MEMORANDUM

TO: Madeleine Reinke, Kimley-Horn and Associates, Inc.
FROM: Cynthia Thye, Planner 1
DATE: December 31, 2025
SUBJECT: SP25-119: Lincoln Professional Park L2 - 7 Brews Coffee – Site Plan Review Comments 02

6 DOOR / HINGE DETAIL
1" = 1'-0"

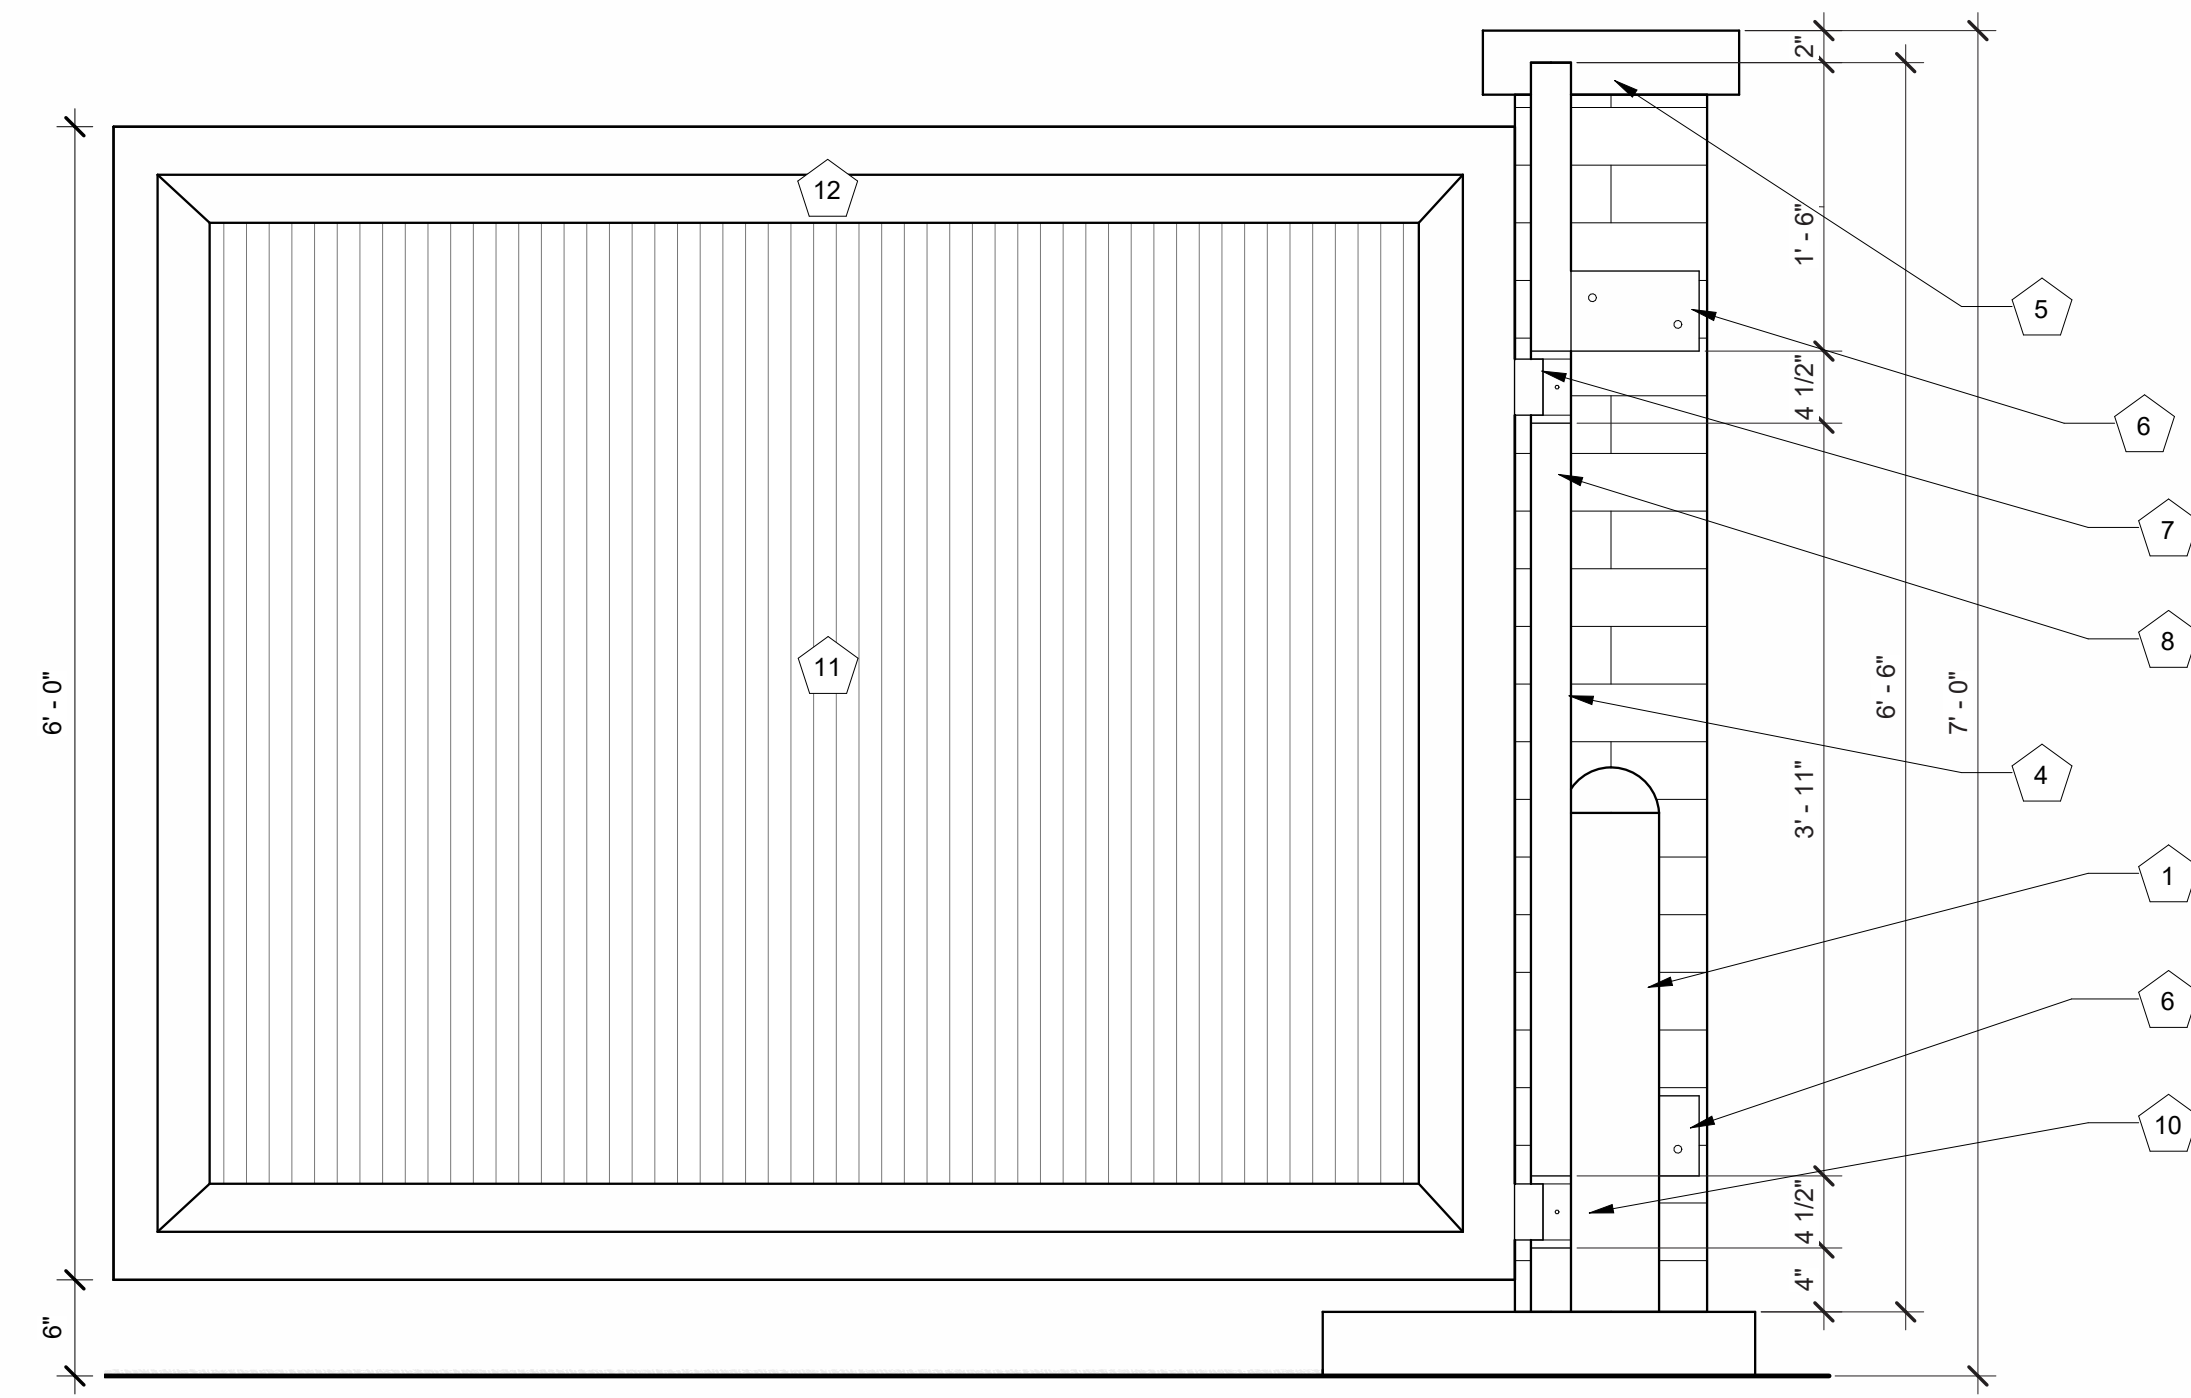
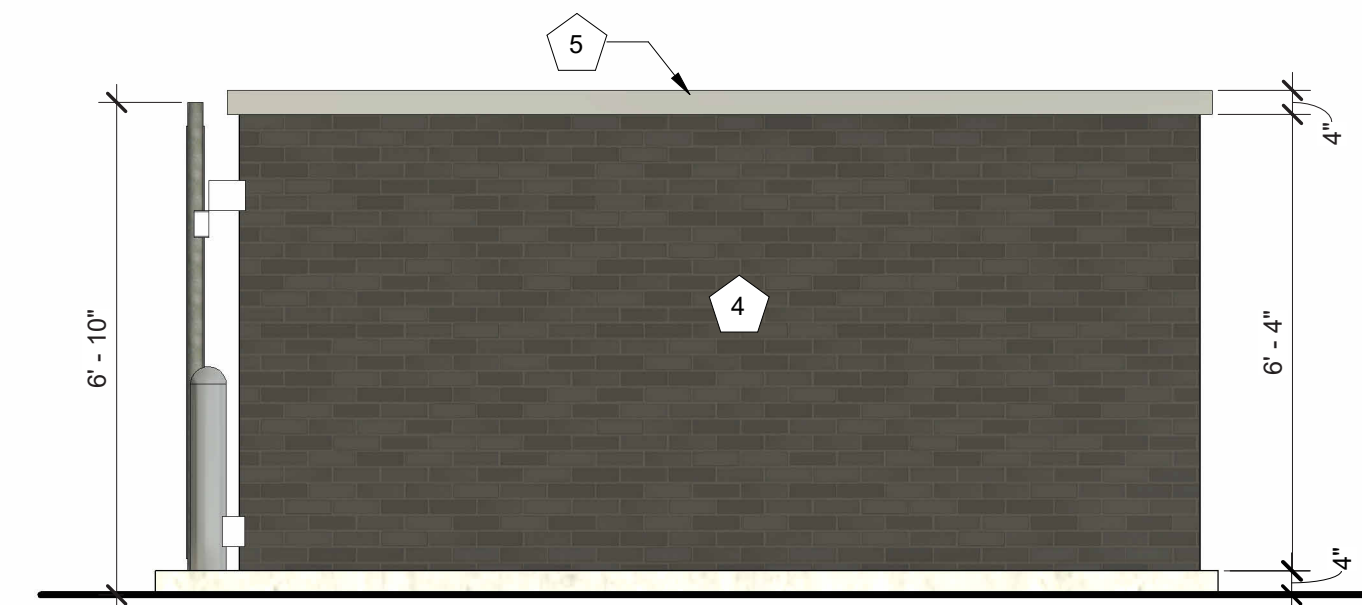
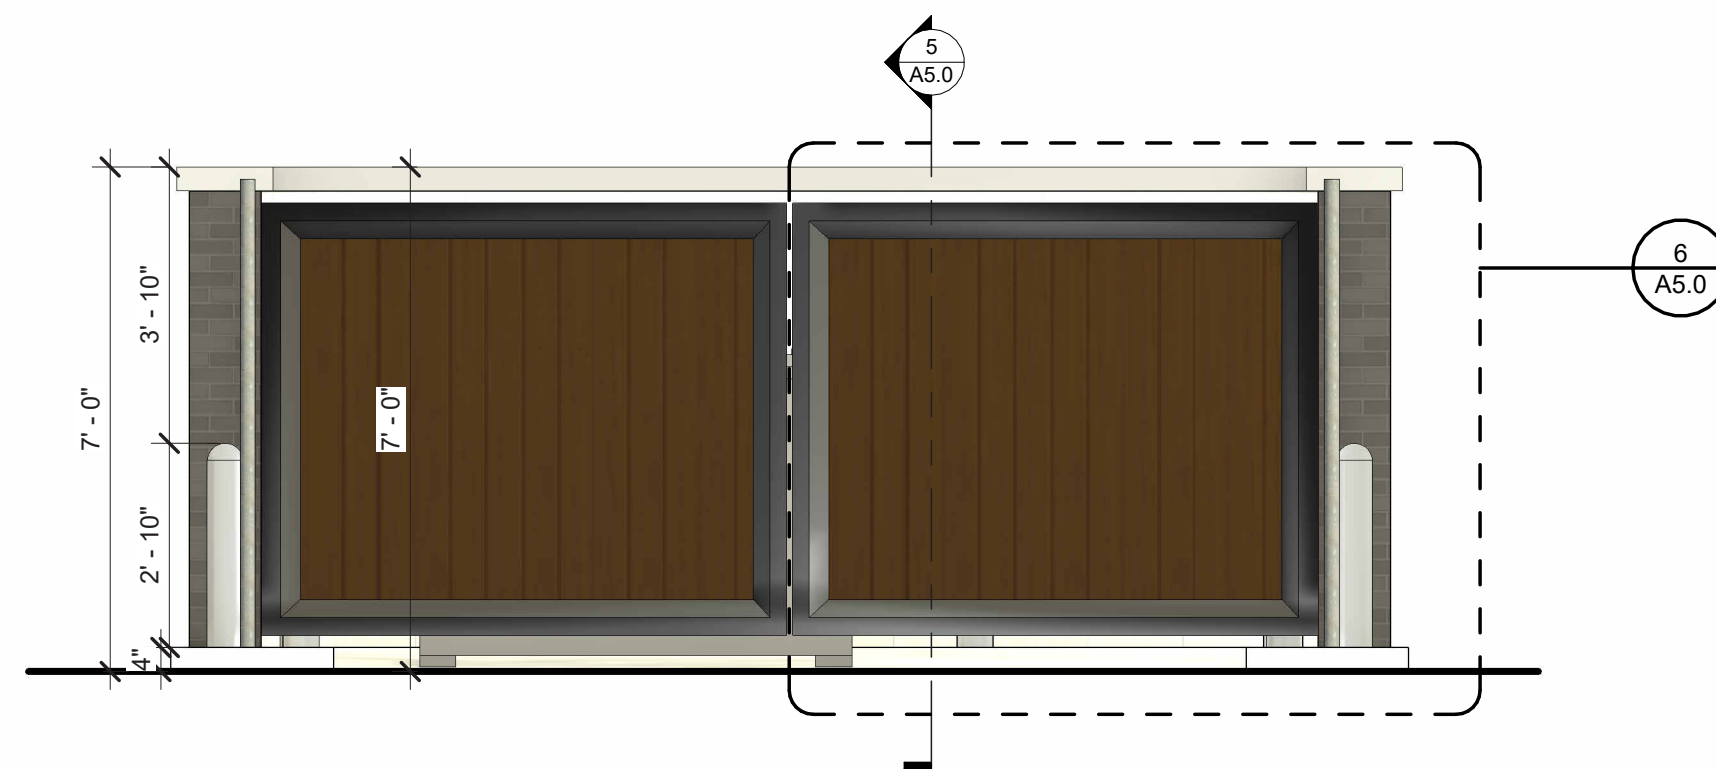
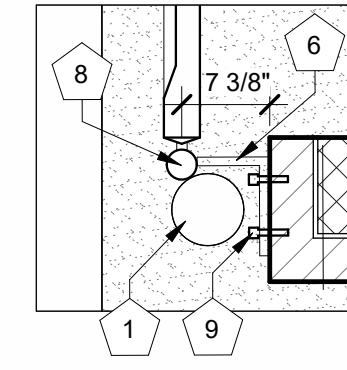
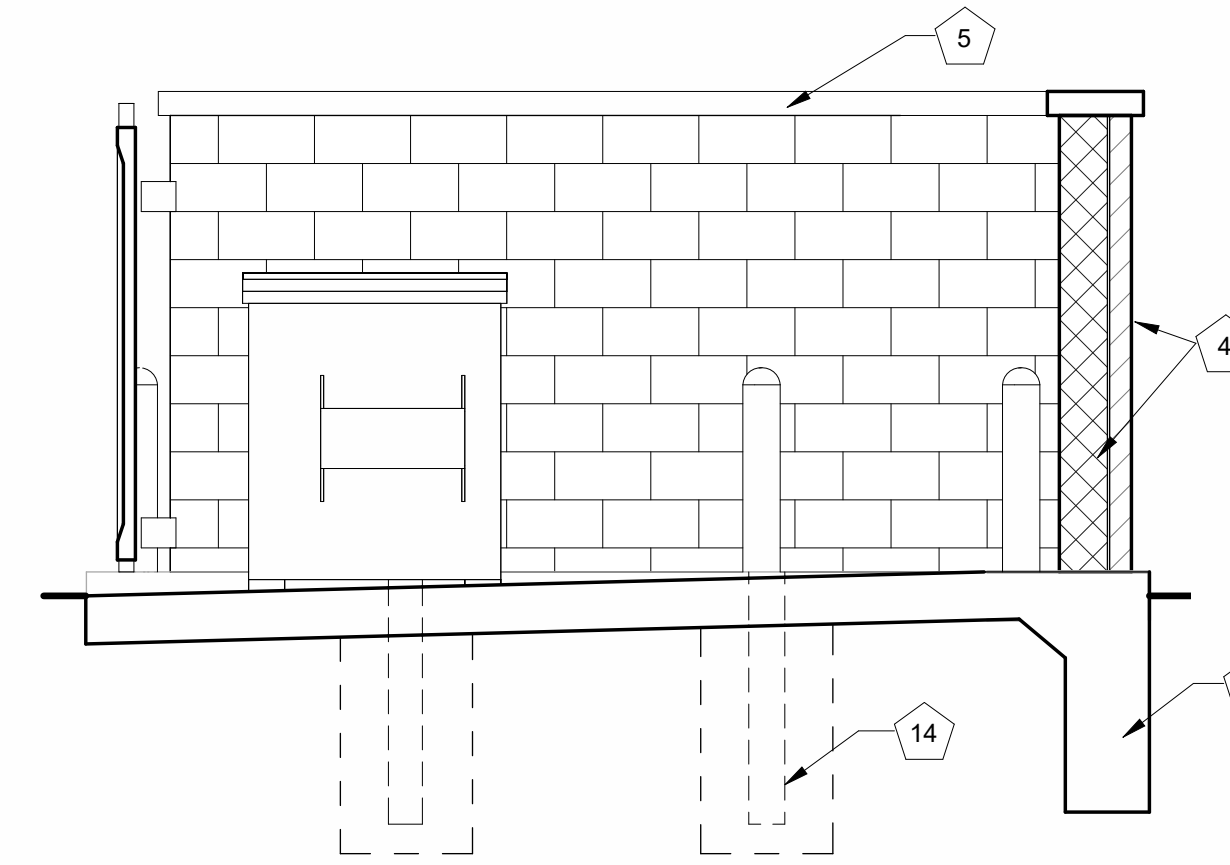
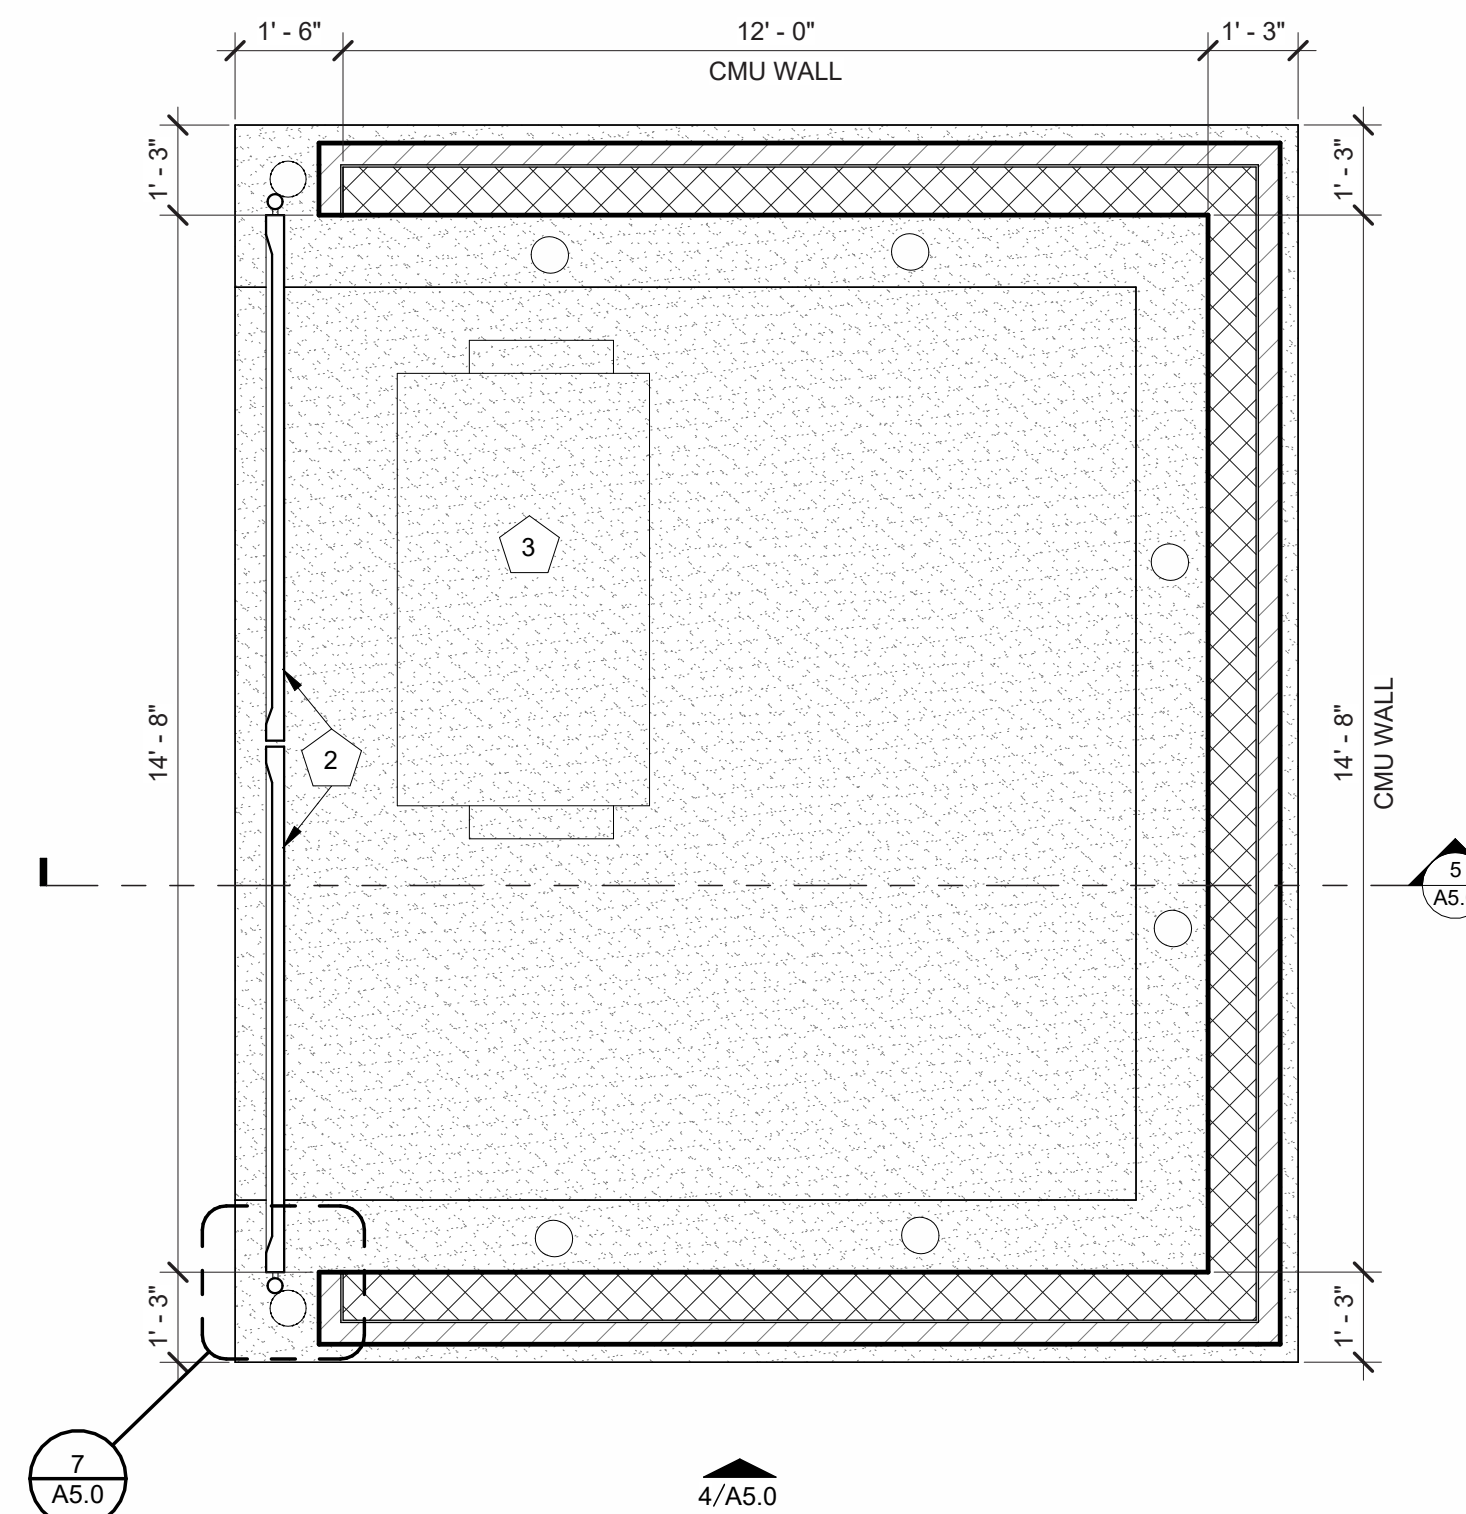
14. Revise trash enclosure doors to be steel painted and color to match main building. Per LDO 13.08.130.

Revise trash enclosure doors to steel painted to match primary structure. For maintenance and durability, these doors will wear easily.
